# Product Change Notification (PCN)

PCN Number	508651	Date Issued	April 20, 2020
Reason for Change	Change to Product		
Change Type Description	<p>This letter is to inform you that changes are being made to the part(s) identified in this Notice. The change may affect the fit, form, function or appearance of the parts, or it may result in a change to the specification. The pictures below show an example of the possible differences.</p>		
Assessment of Change	<p>Product will be fully qualified before it is shipped. Qualification reports will be available after below listed date</p>		
Internal Molex Qualification Date	March 23, 2020		
Sample Availability Date (Changed Part)	March 23, 2020		
Planned Implementation Date	October 31, 2020		
Method of Identifying Change	Date code

Before change

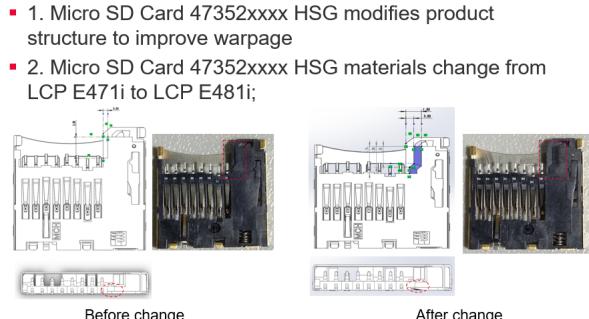
- 1. Micro SD Card 47352xxxx HSG modifies product structure to improve warpage
- 2. Micro SD Card 47352xxxx HSG materials change from LCP E471i to LCP E481i;
- 3. Appearance contrast is not obvious.
- 4. Change reason :
  - a. Improvement of Warpage Deformation.
- Product Impact
  - No impact to fit, form or function
- Part Number Impact
